## REGULAR MEETING CONSERVATION COMMISSION

4:00 P.M. July 9, 2025

## Memo

SUBJ: July 9, 2025 Conservation Commission Meeting

Weston & Sampson Engineers, Inc.
150 Dow Street, Tower 4, Suite 350
Manchester, NH 03101
978.532.1900 800.SAMPSON

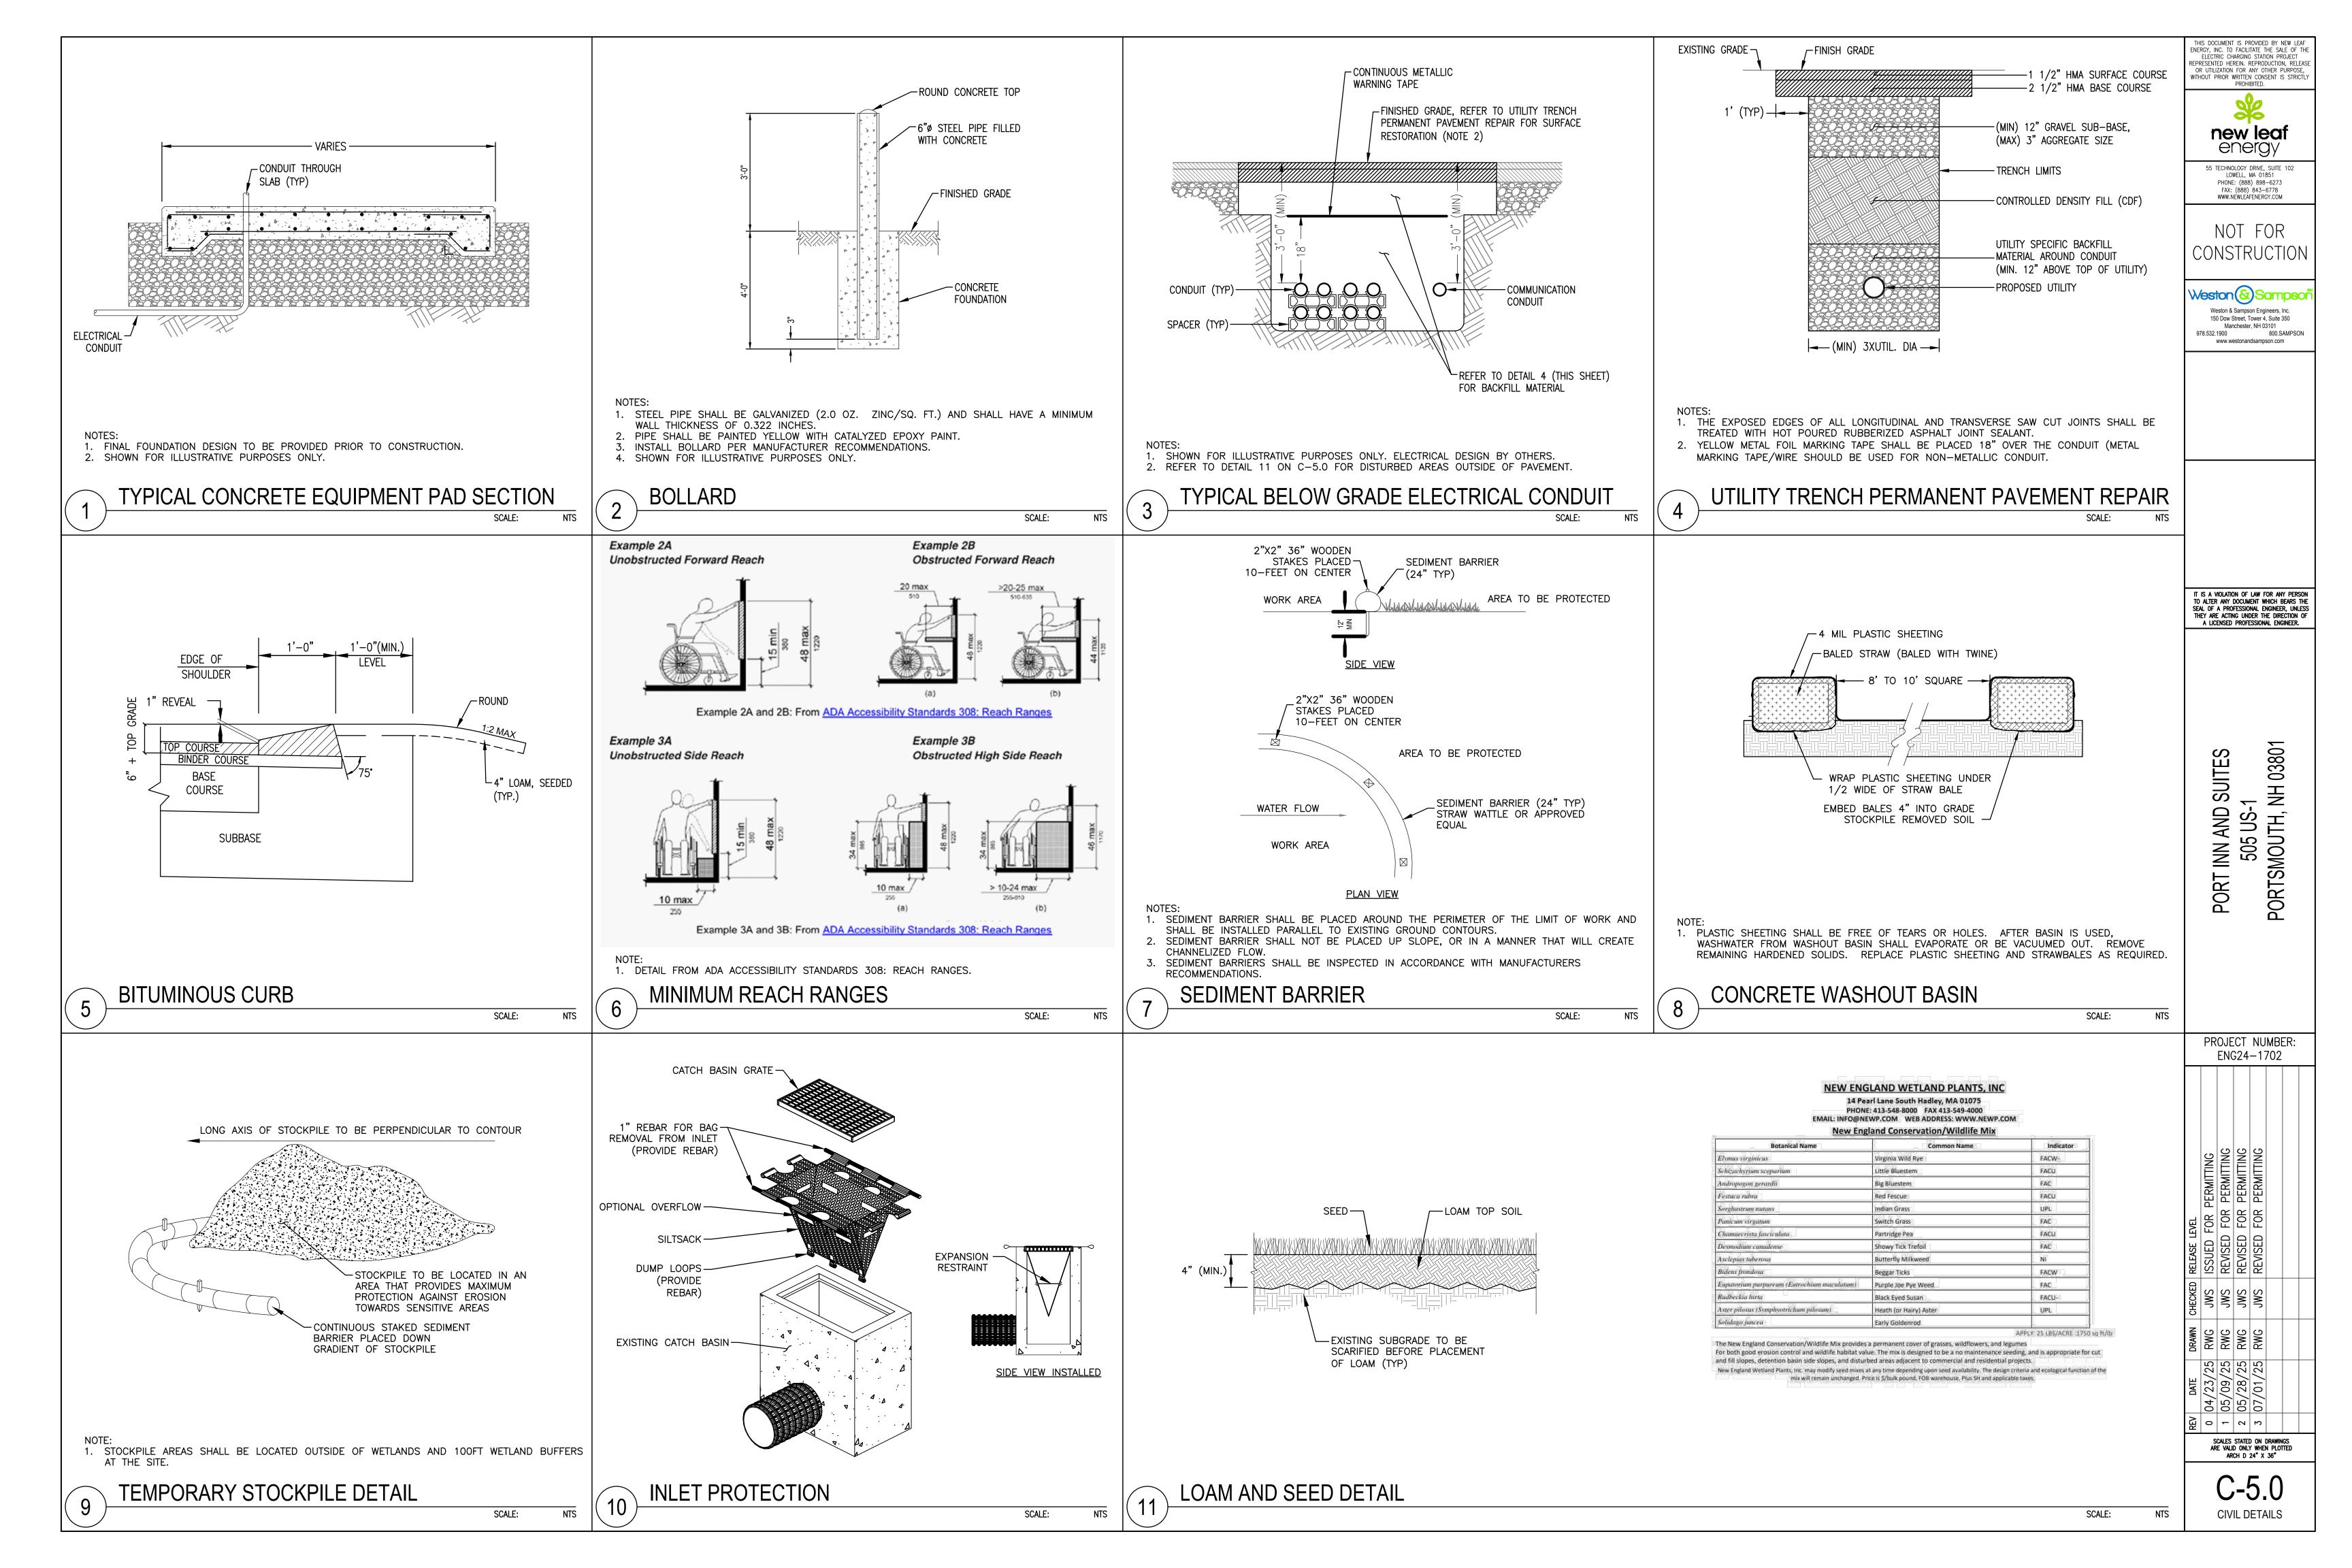
This project is for the installation of four new electric vehicle charging stations within the parking lot of the property. This would include creating and/or re-striping eight parking spaces and installing the necessary equipment and utility connections needed. This work will occur within the wetland buffer of Hodgson Brook and includes the removal of 2,135 s.f. of existing asphalt and converting to wetland buffer seeded area. It also includes 173 s.f. of permanent impacts to an existing landscape section within the buffer to install the transformer and concrete pads. In total, this project will create a net impervious of 1,962 s.f. within the 100' buffer.

The existing site is asphalt and is reasonably suited for the installation of such infrastructure.

The EV chargers have been located as far away from the wetland resource as possible while still being able to maintain the same number of parking spaces. The applicant is removing a significant amount of impervious from the vegetated buffer, planting native species and shifting the new infrastructure further from the brook.

The brook is already a heavily impacted resource and bolstering its buffer is critical to its protection. The removal of pavement between the proposed chargers and the brook will help to reclaim part of the wetland buffer. In addition to removing impervious, the applicants are also proposing to establish new plantings within the new pervious areas and maintain the intended existing drainage on the site.

This project proposes alterations with the construction of new transformers and concrete pads but plans to remove existing pavement and replant which will help offset those impacts.

The removal pavement from the 40' vegetated buffer strip and the installment of seed mix and plantings will be an improvement.

**Recommendation:** Staff recommends approval of this wetland conditional use permit to the Planning Board with the following conditions:

1. In accordance with Section 10.1018.40 of the Zoning Ordinance, applicant shall permanently install wetland boundary markers, which may be purchased through the City of Portsmouth Planning & Sustainability Department. Markers are to be placed along the 25' vegetative buffer at 50-foot intervals and must be permanently installed as a part of this after the fact permit.
